SERVICE BULLETIN No. 292 72 2239

Version: A

Date: 10 June 2024

Subject:
Module M01 - Magnetic seal assemblies installed on starter gear.
Modification of the preformed packings.
Modification TU 239.

Figure 1

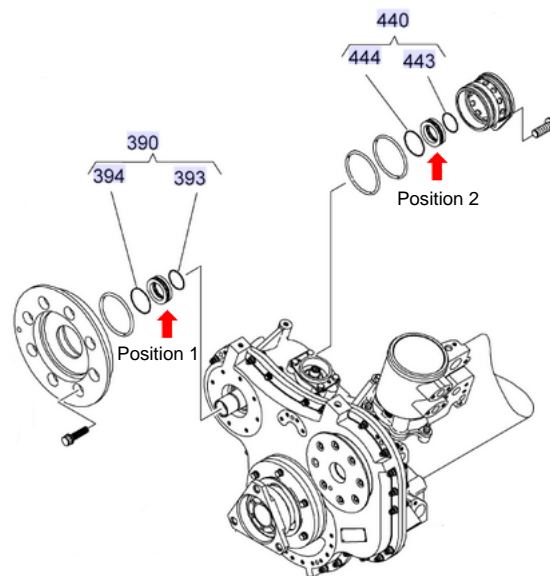
Operators of ARRIEL 2 engines found oil leaks on the magnetic seal assemblies Position 1: seal of the Dynastart adapter and Position 2: seal of the breather cover (see figure 1) installed on the starter gear of the accessory gearbox module (M01).

Items 390 and 440 of magnetic seal assemblies
 Items 393, 394, 443 and 444 of preformed packings

The investigations done by Safran Helicopter Engines on the magnetic seal assemblies Position 1 and Position 2 highlighted damage to preformed packings linked to premature aging. It was also shown that the material of the preformed packings was not optimum when these seals were used in a HTS (High Thermal Stability) oil environment.

Modification TU 239 introduces new preformed packings in the magnetic seal assemblies Position 1 and Position 2 made from material compatible with HTS oils.
